I PROJECT:	Wynot Public School Addition & Renovation	PROJECT NO.	L14208
FROM:	BVH Architects	DATE:	17 March 2016
TO:	All Bidders	ADDENDUM NO.	1

Wynot Public School Addition and Renovation
R.O. Youker, Inc. Project #16005
Addendum 1 Items
3/17/2016

addendum no. 1

A1 WINDOW FRAME ELEVATIONS

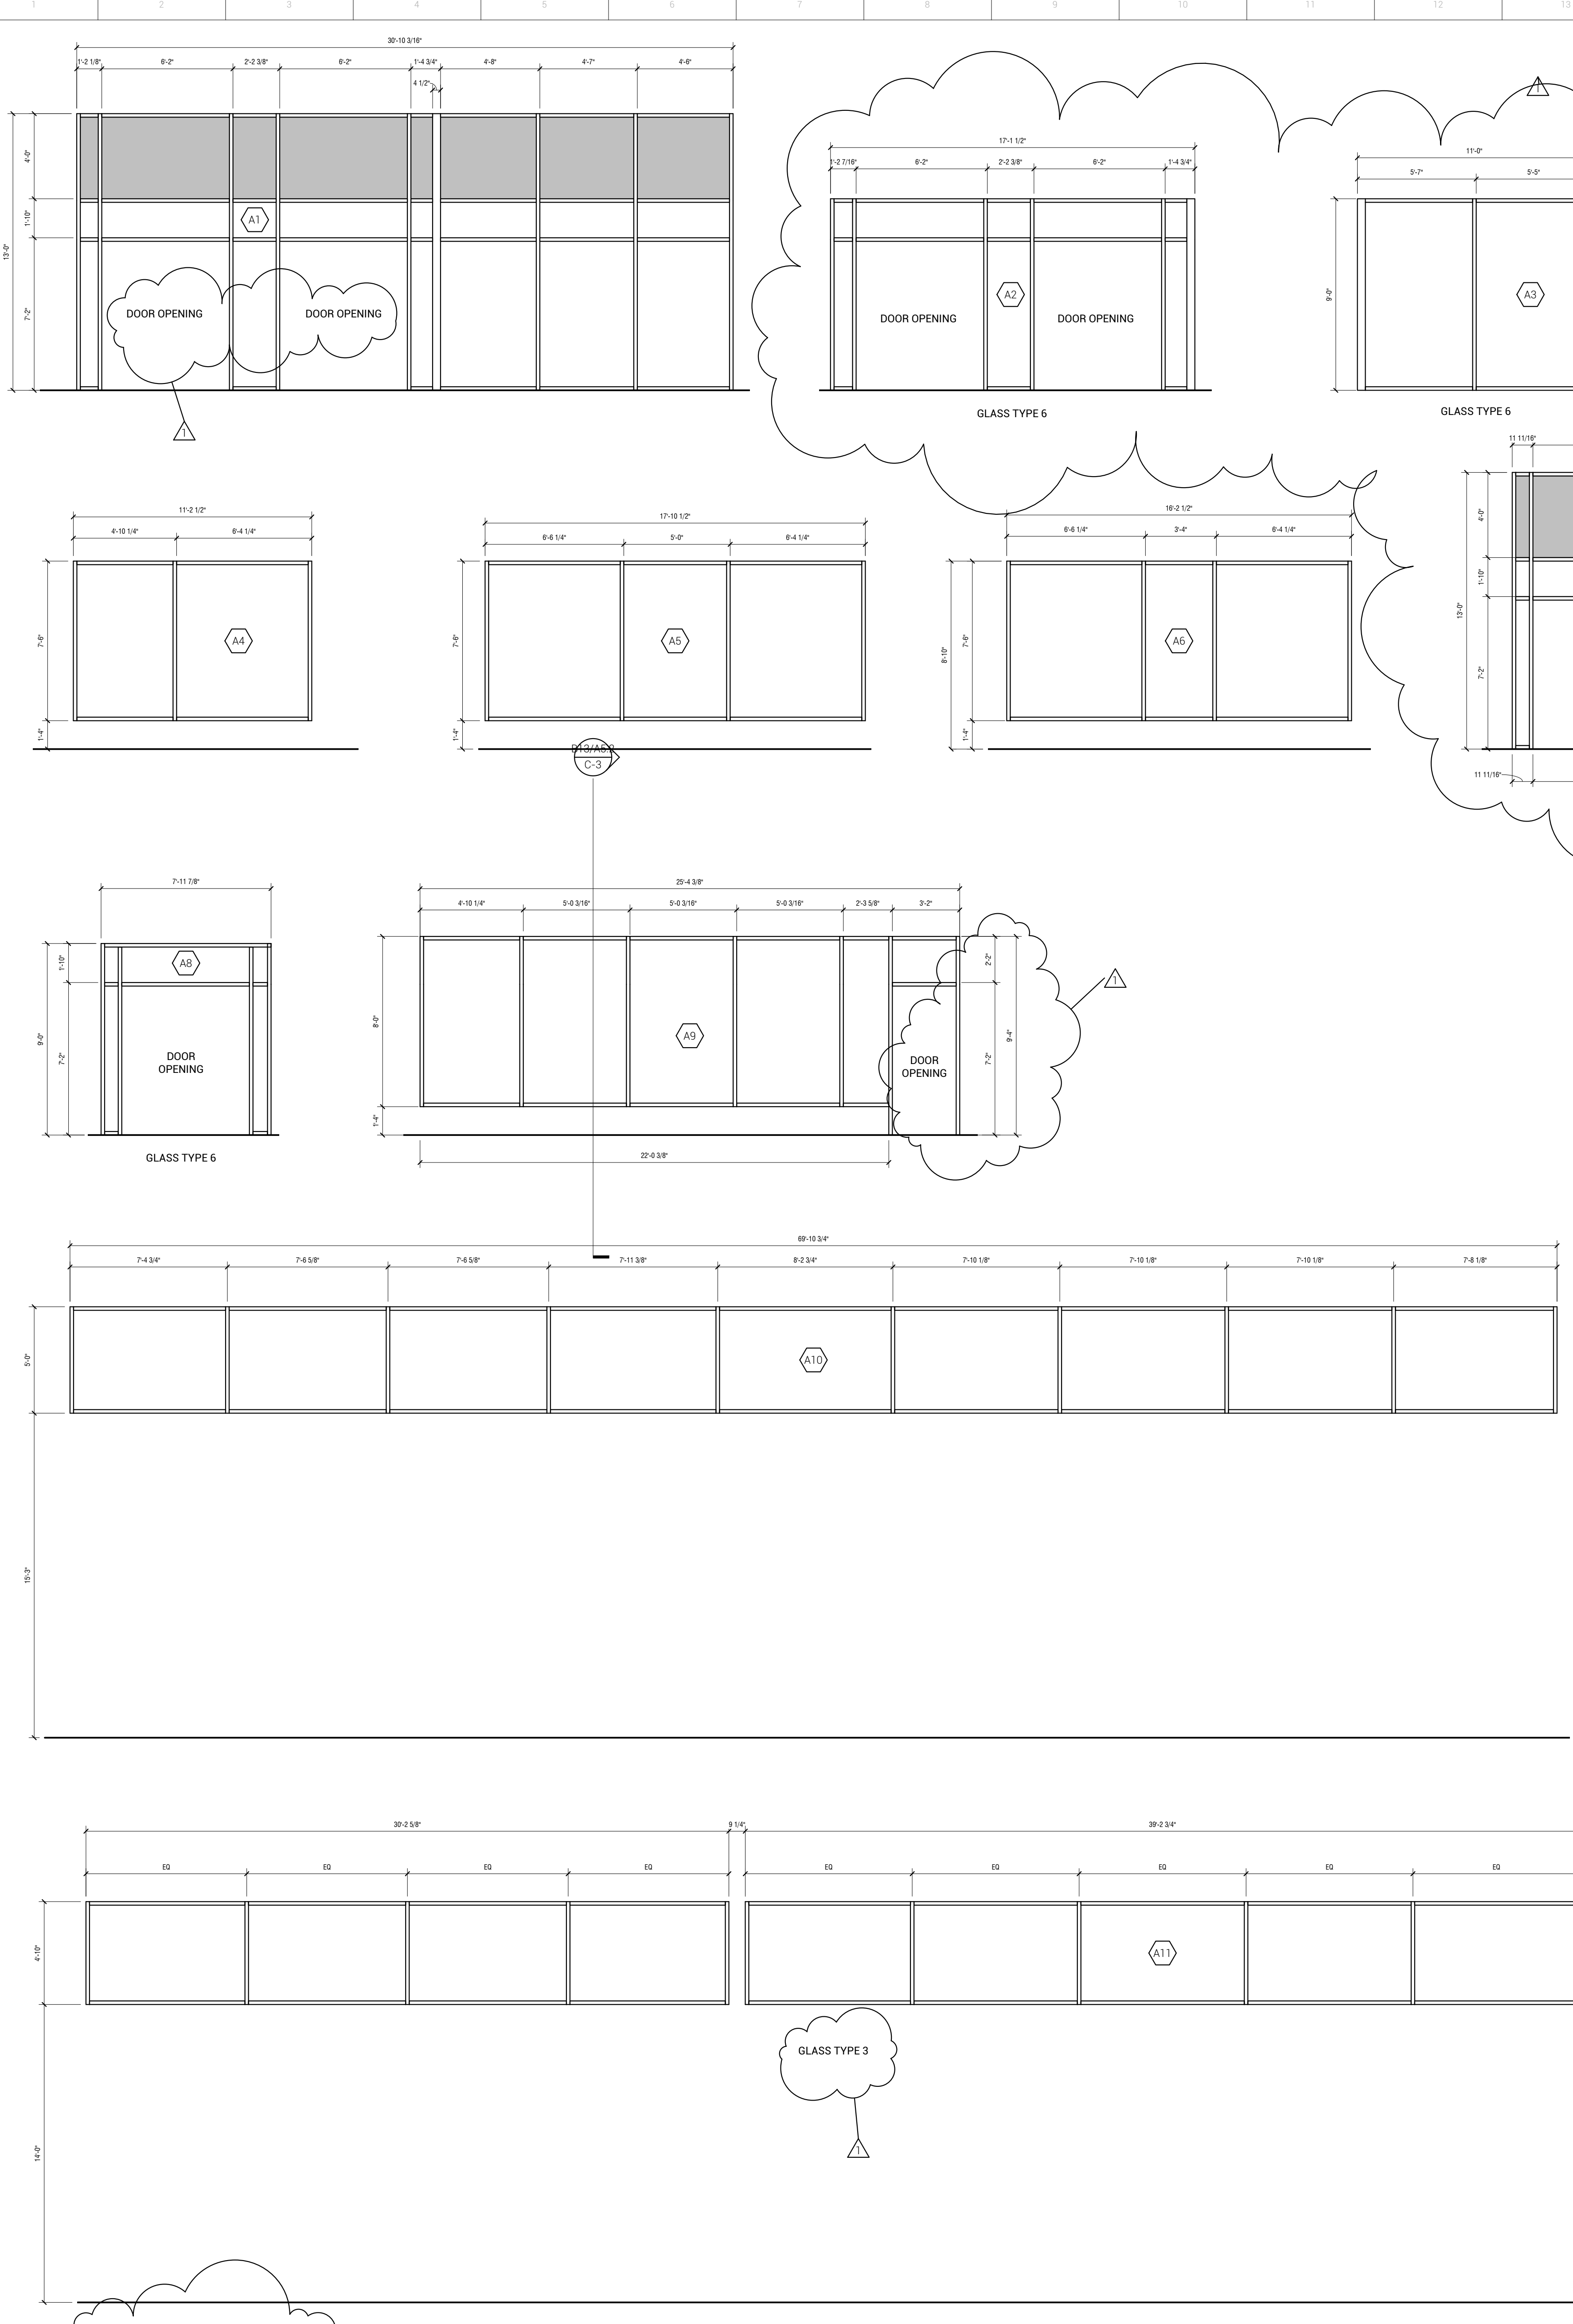
- a. Detail A1 Window Frame Elevations
 - 1. Change frame types A1 and A7 to Kawneer Trifab 601T Framing System
 - 2. Glass types noted.
 - b. Door Schedule revisions.
 - c. Miscellaneous revisions on sheet.
10. Sheet A8.1 First Floor Finish Plan (refer to re-issued sheet A8.1)
- a. Materials List and First Floor Finish Plan revisions.

aS-1
 Ref Sht: S1.0

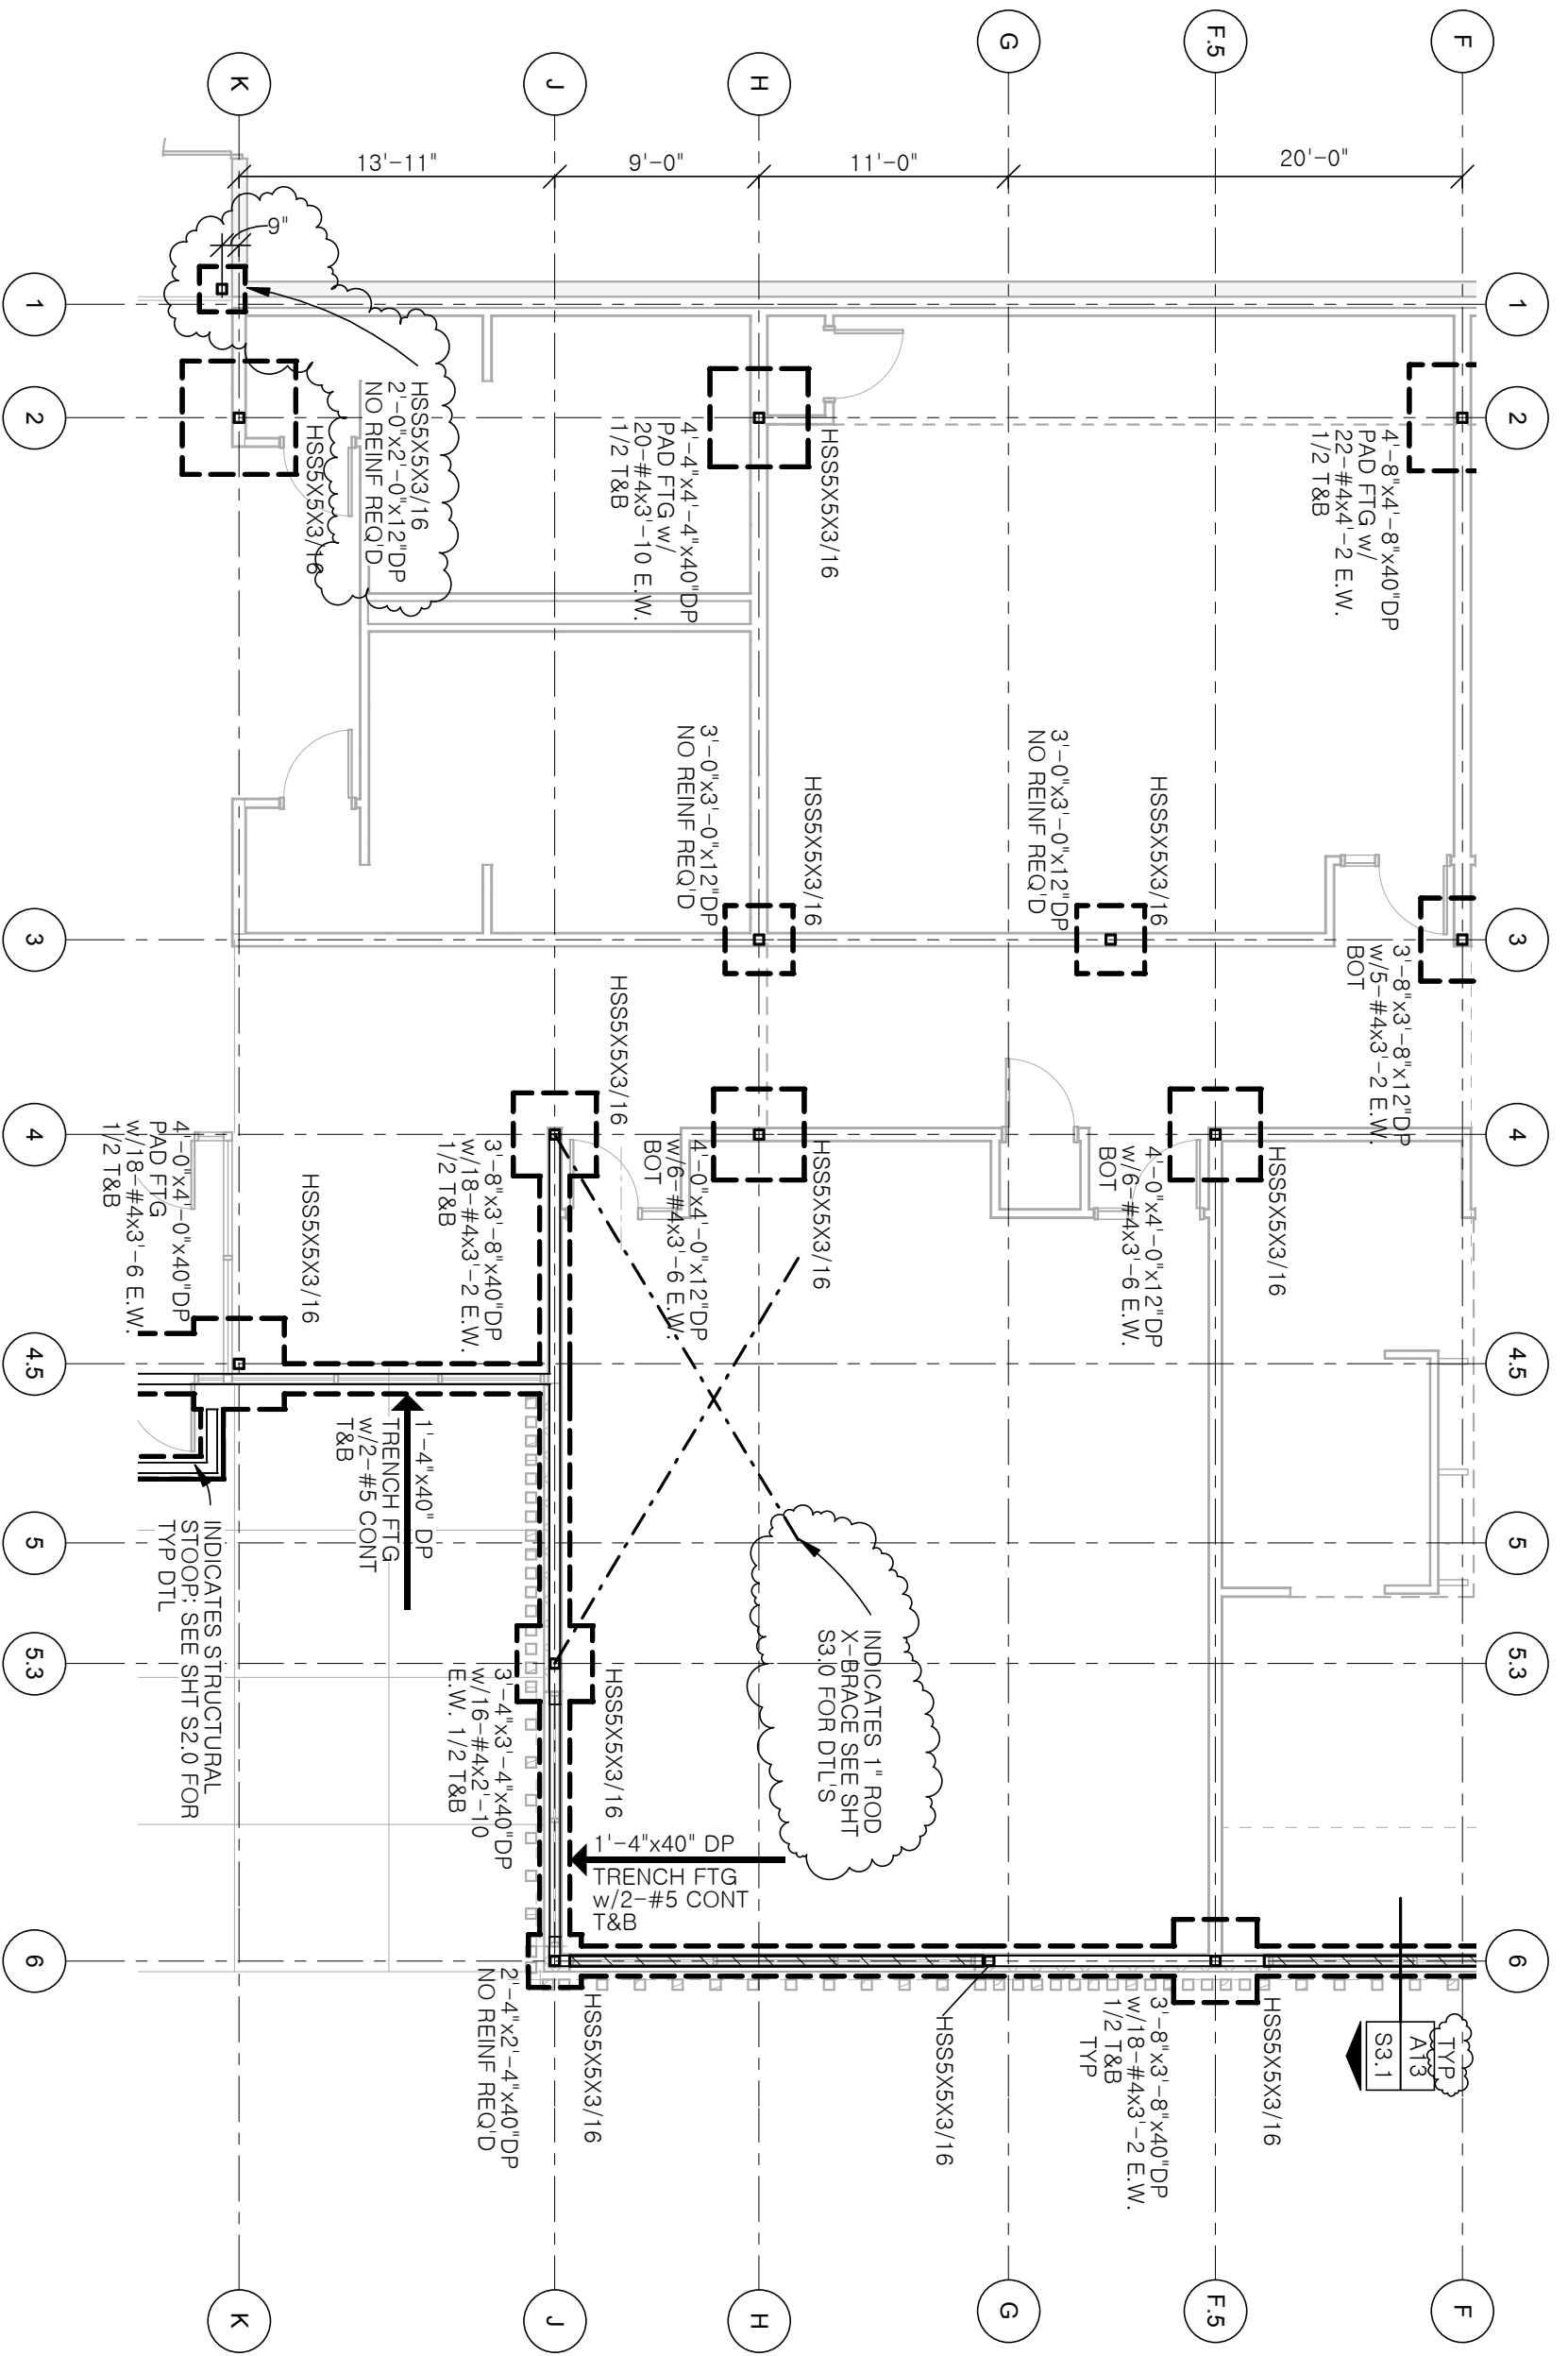
1. *What does the W12x30 beam tie into or bear on at the metal building?*
 - a. An additional column and footing has been added for beam bearing next to the existing metal building. See attached sketch.
 - b. South end will bear on the existing masonry block. See DTL S6/S3.0 for attachment. No bearing plate required at this location.

9. *Sheet S1.0 references "sheet S2.1 for details" between grids 4 & 5 along J & H.
We do not have a sheet S2.1 in our plan. Please clarify if this is reinforcing
poured in the slab.*

- Changes include an additional column and footing, added dimension for new column and revision to note on plan. Refer to attached sketch aS-1 for changes shown in clouded regions.

This should reference sheet S3.0 and is in reference to our cross bracing detail.
This revision has been shown on the attached sketch aS-1.

REVISED DTL P21/S2.0

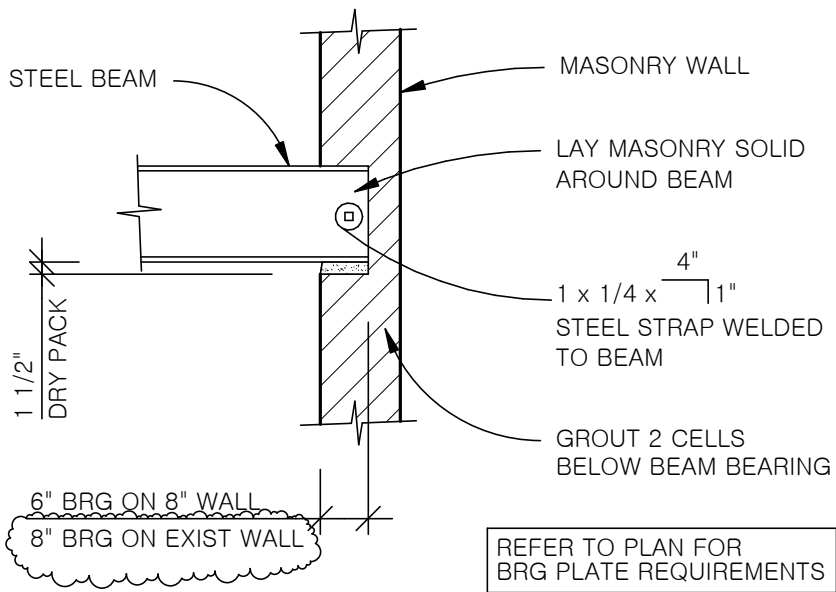
- On detail P21/S2.0 we included a note requiring 8" bearing on existing masonry walls. See attached sketch aS-2.

ES1

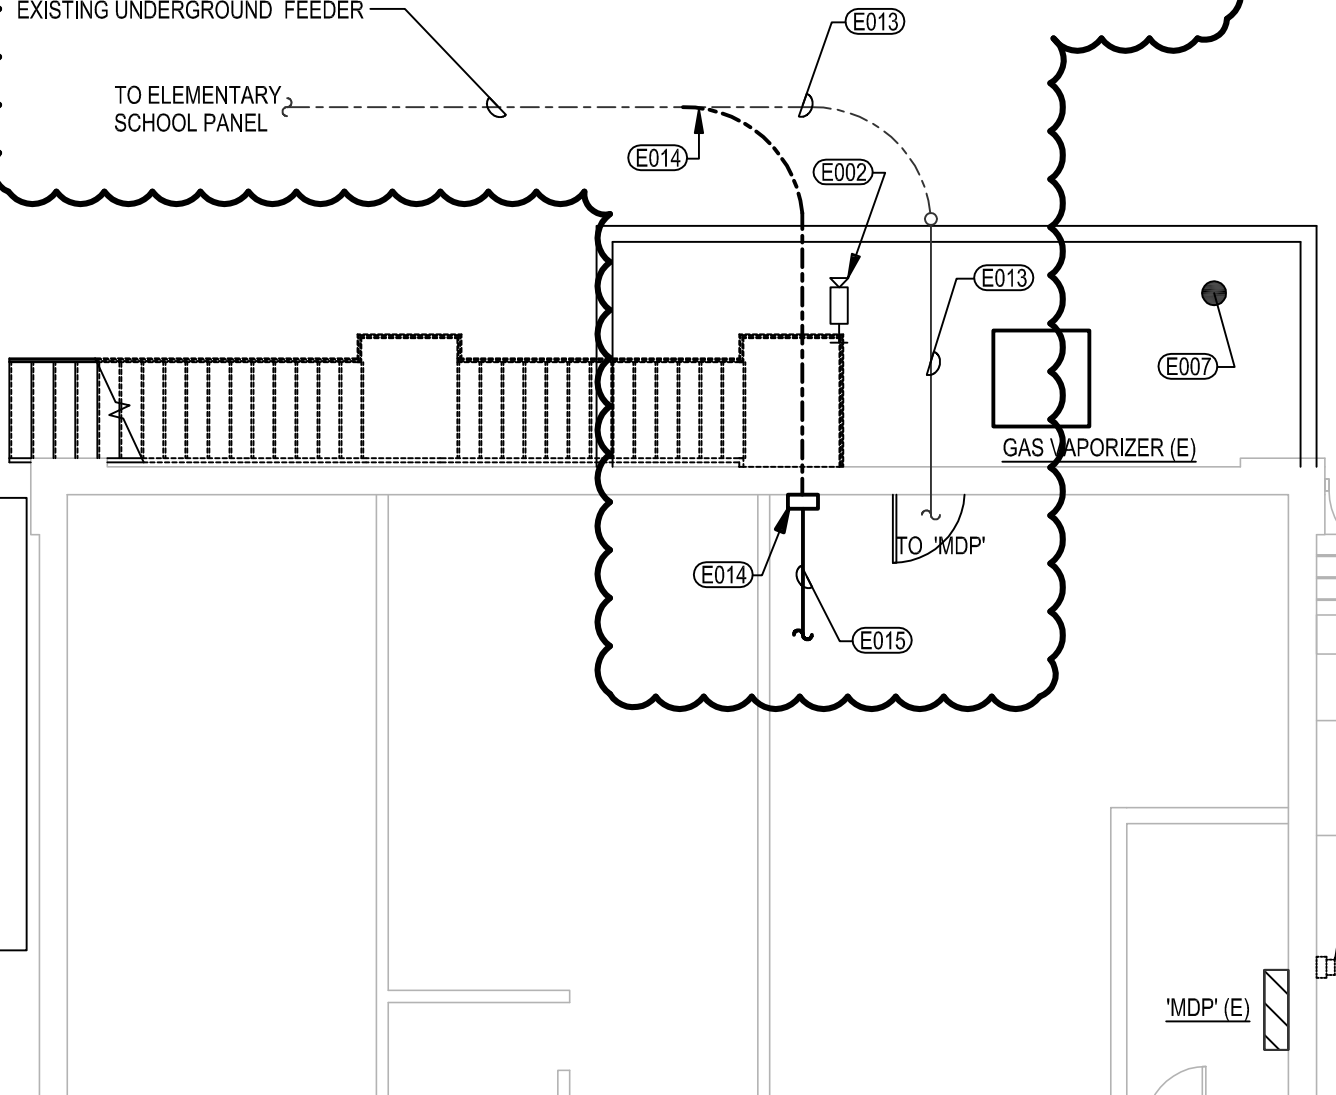
2. Sheet E0.1 – First Floor Electrical Demolition
 - i. See attached supplemental drawing ES1 for additional work.
3. Sheet E1.1 – First Floor Plan - Lighting

- E013 INTERCEPT BELOW GRADE CONDUIT AND REMOVE CONDUCTORS FROM AREA TO BE DEMOLISHED, PROTECT CONDUCTORS FROM DAMAGE DURING CONSTRUCTION.
- E014 EXTEND EXISTING 2 1/2" CONDUIT WITH EXISTING CONDUCTORS TO NEW JUNCTION BOX IN MECHANICAL ROOM. PROVIDE A 24" x 24" x 8" NEMA 1 JUNCTION BOX.
- E015 FROM JUNCTION BOX TO EXISTING CIRCUIT BREAKER IN PANEL 'MDP' PROVIDE: 3-#4/0, #2/0 NEUTRAL, #6 GROUND IN 2 1/2" E.M.T.
